INFORMATION NOTE

N° 015/15

Implementation of a close dambar leadframe design for PG-DSO-20

Description of Change:

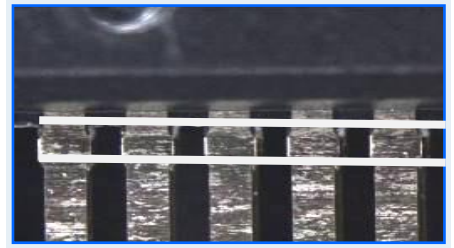
Subject of Change: Change of leadframe design to a close dambar design.

Reason of Change: Harmonization of leadframes.

No impact on electrical parameters.
No impact for pick and place at board assembly expected.
